ADDENDUM NO. 2

RE: **Athletic Performance Addition**
Perkinston Campus, MGCCC
Perkinston, Mississippi
A/E Project No. 26-028a

FROM: EGH Architects
1091 Tommy Munro Drive
Biloxi, MS 39532
(228) 594-2323

2 WATER HEATER DETAIL
SCALE : N.T.S.

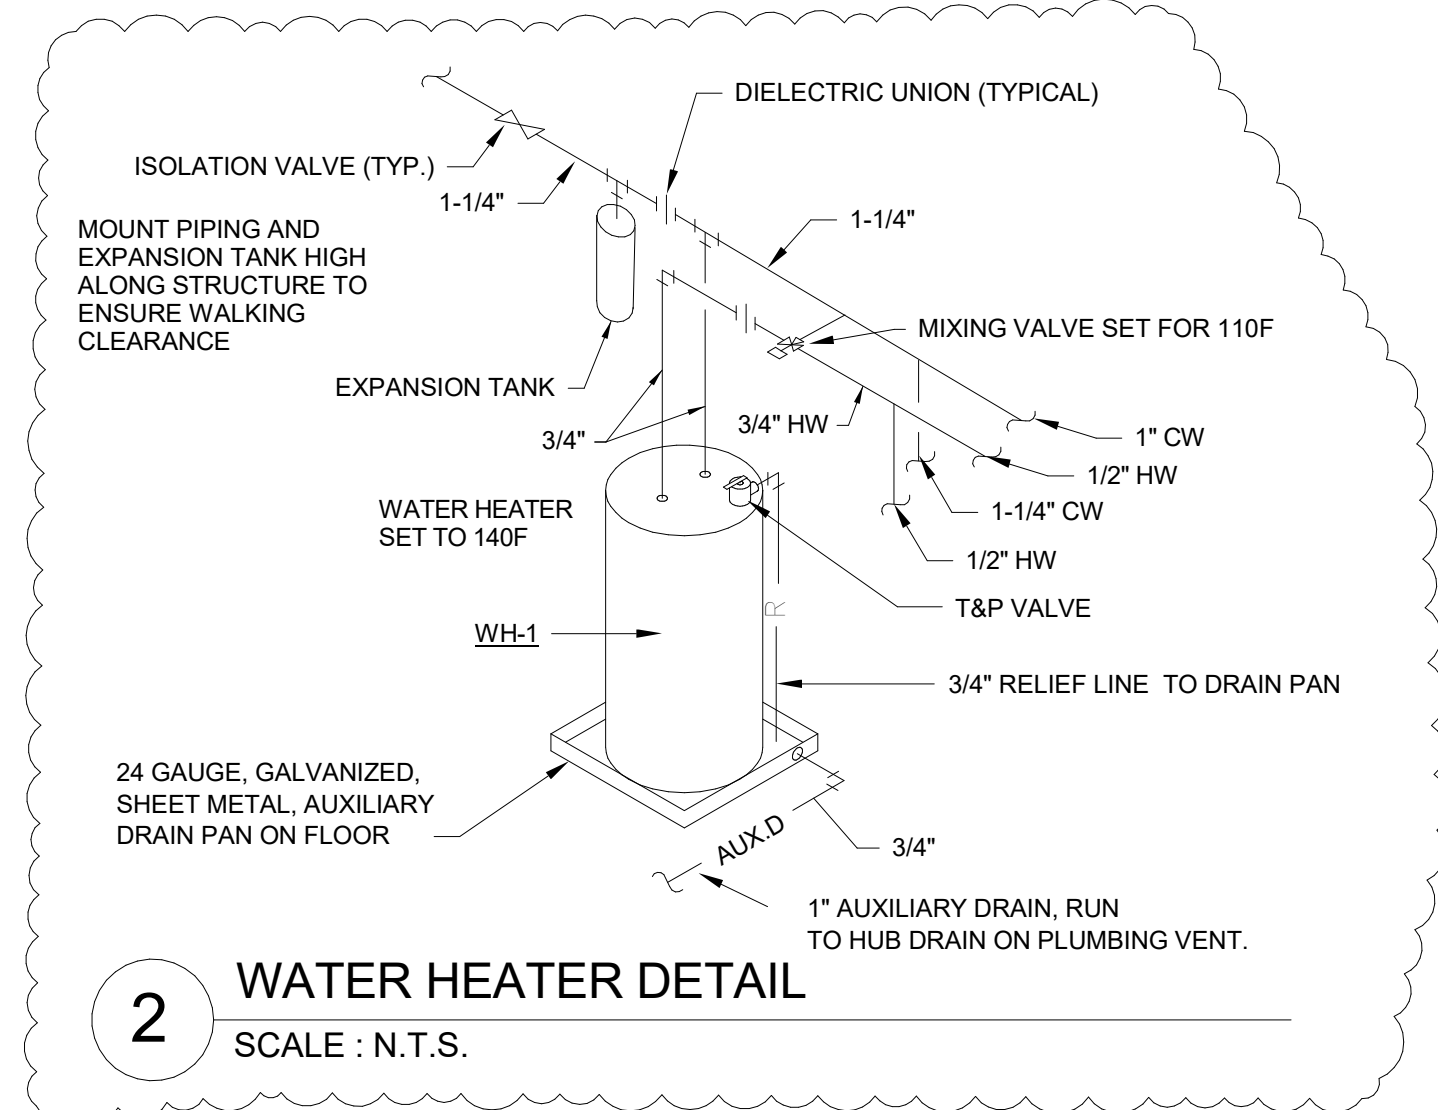
- Water heater detail updated to reflect the new water lines. The auxiliary drain line has been changed from routing to the outside and should now be routed to a trapped hub drain connected to the nearest plumbing vent.

1 ABOVE GRADE PLUMBING PLAN
1/8" = 1'-0"

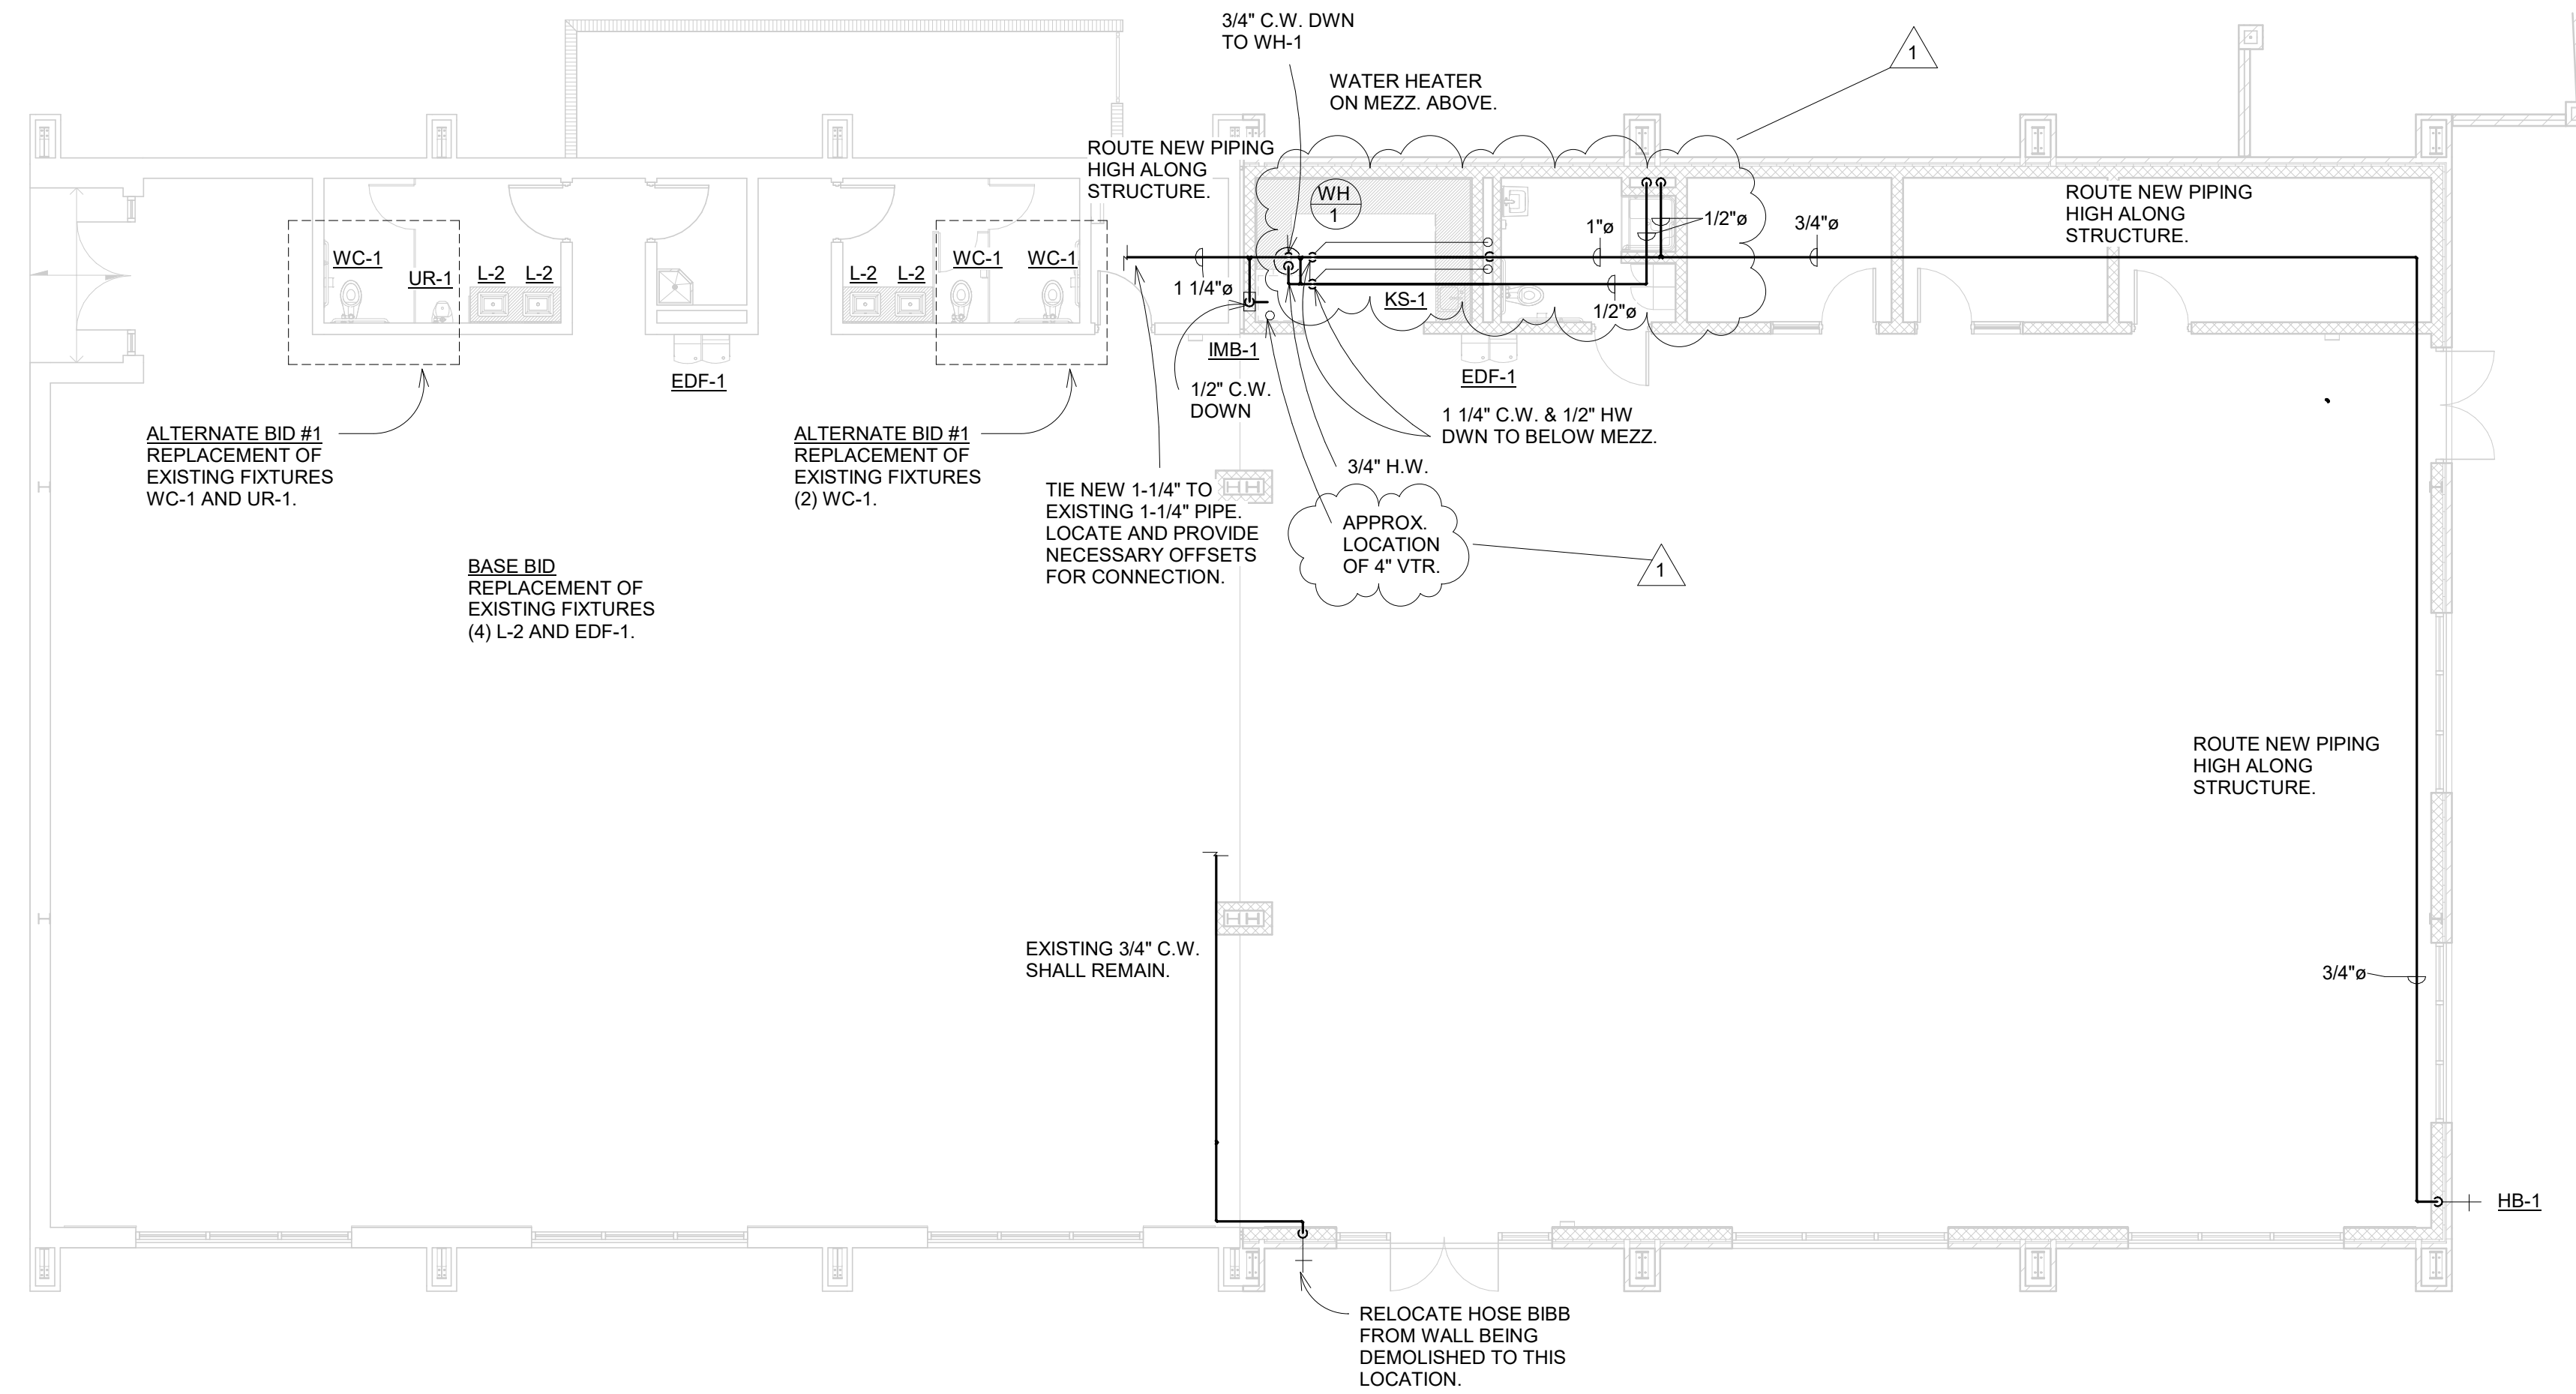
- Note changed for coordination with HVAC equipment.
- Water heater moved and piping shown going down through mezzanine floor to avoid conflict with air handler location.
- Approximate location of 4"VTR shown for reference.

1 REFRIGERANT PIPING PLAN
1/8" = 1'-0"

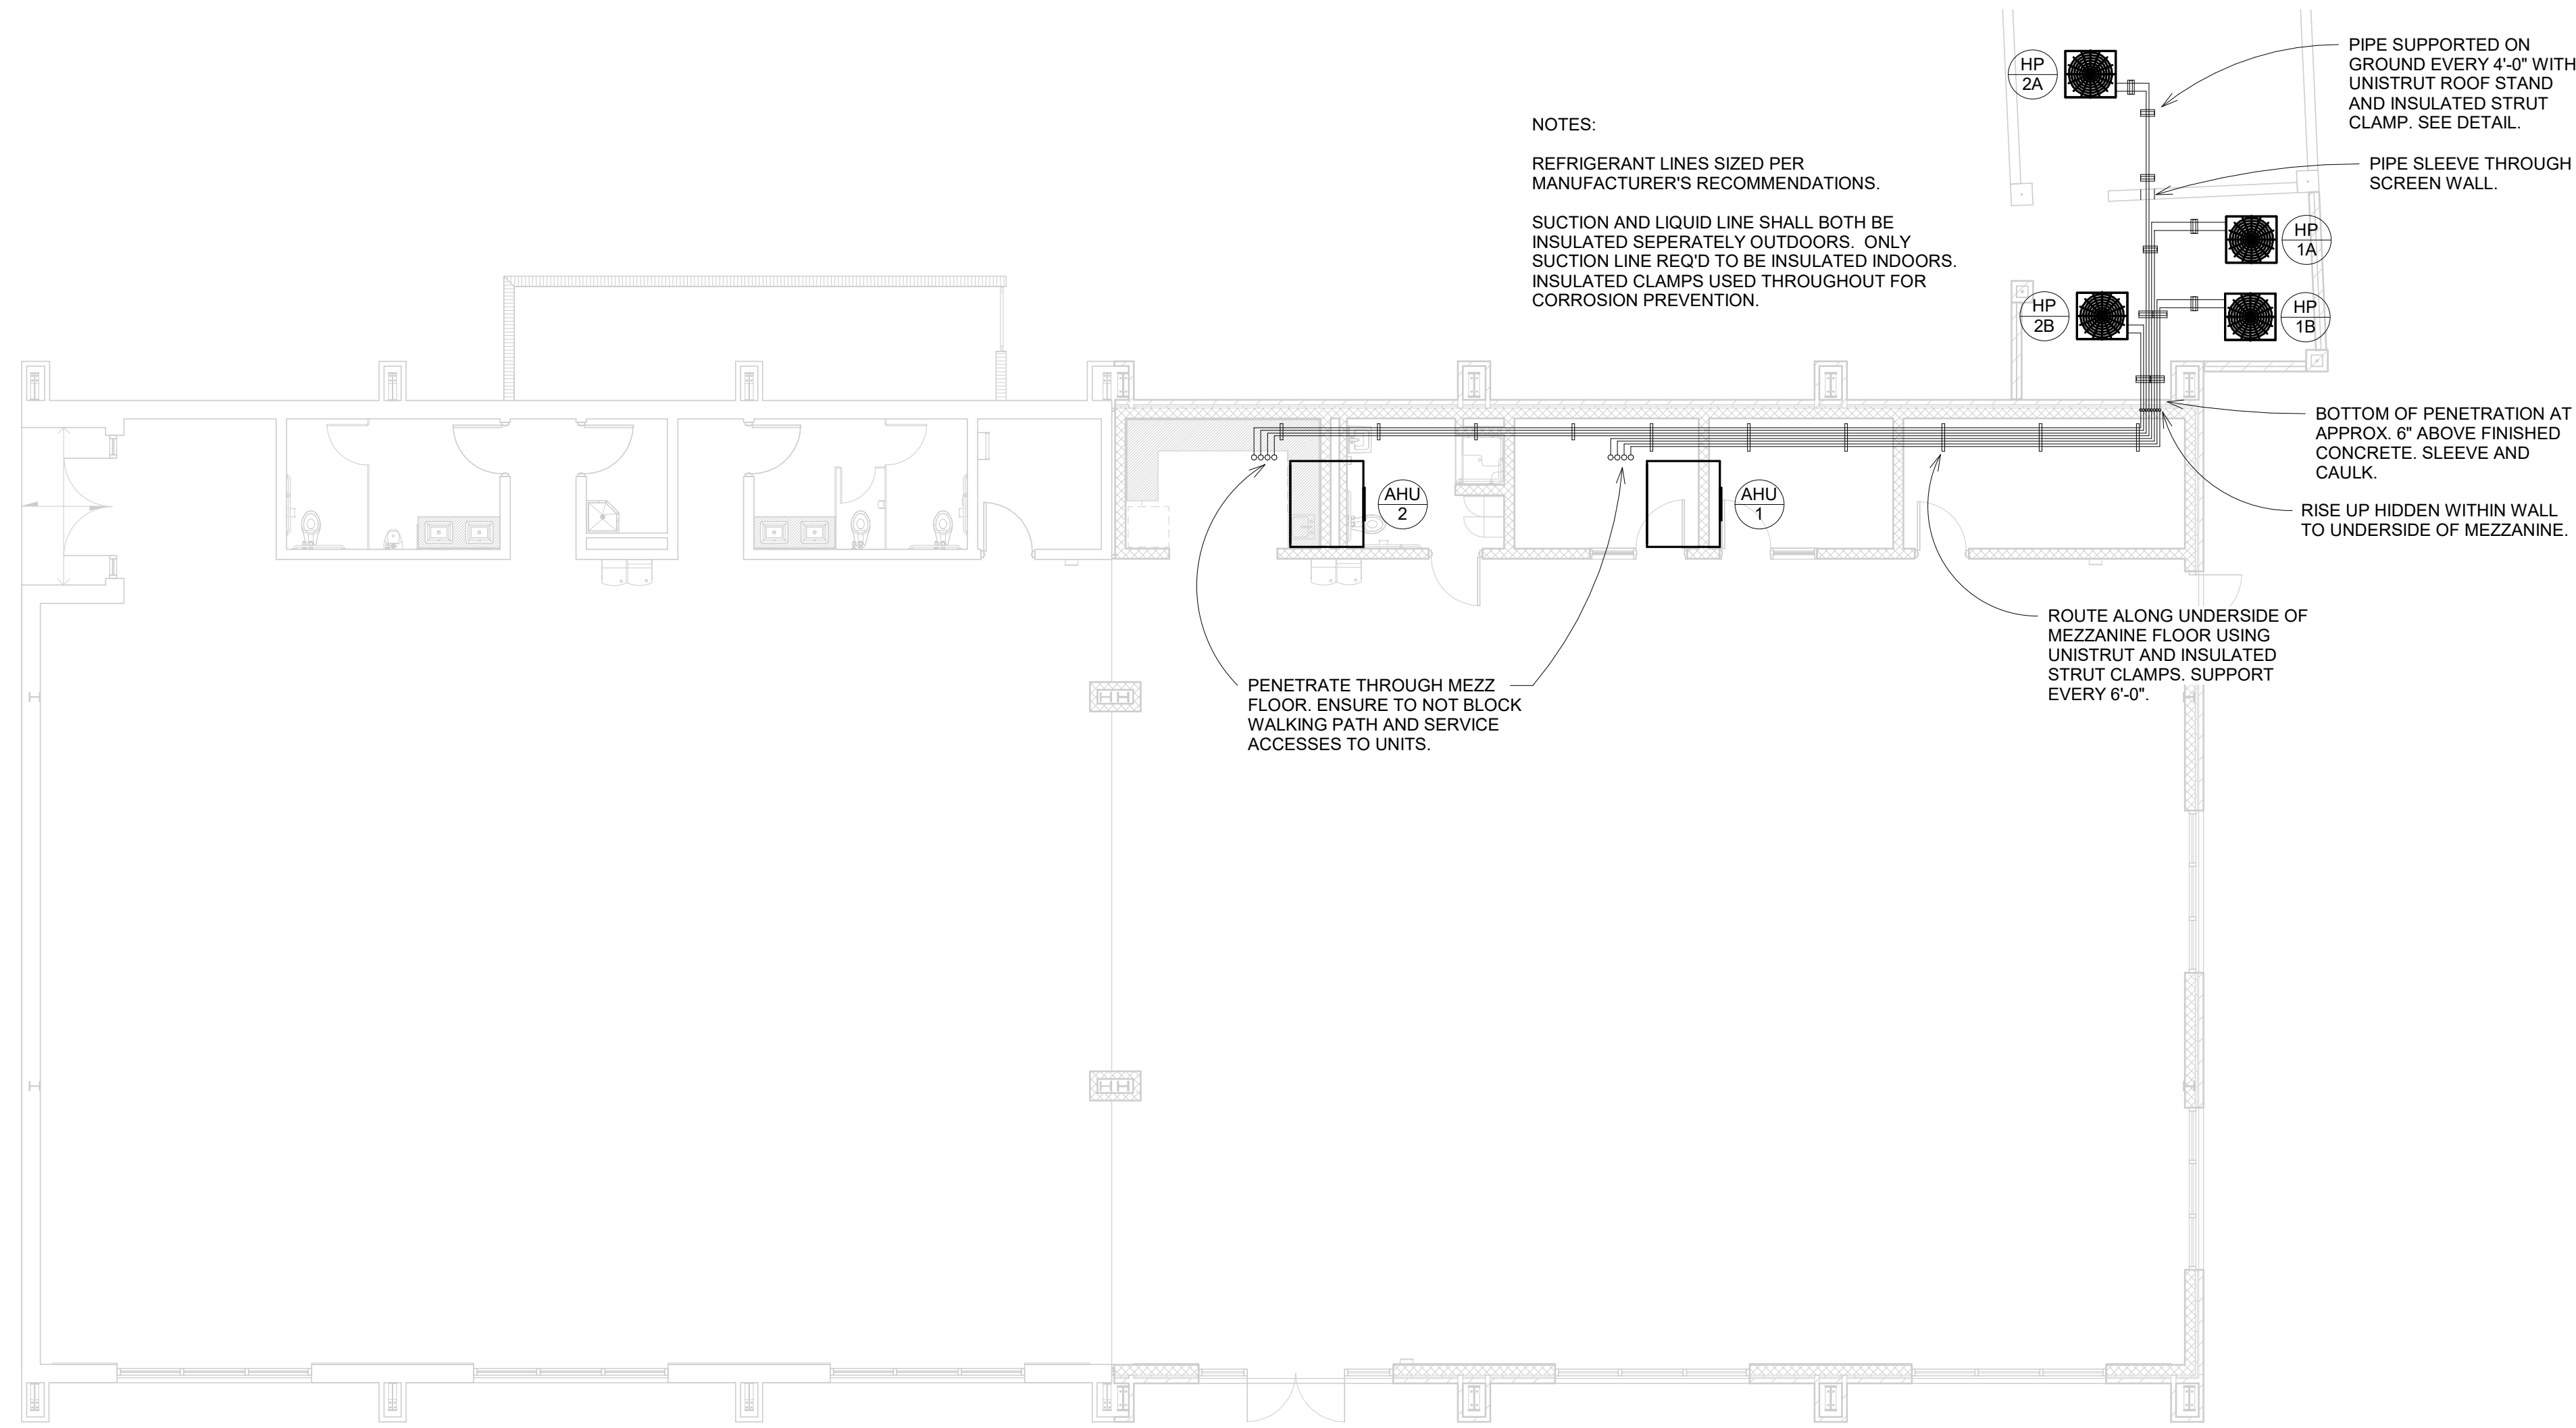
- Sheet added to show refrigerant piping plan and related details.
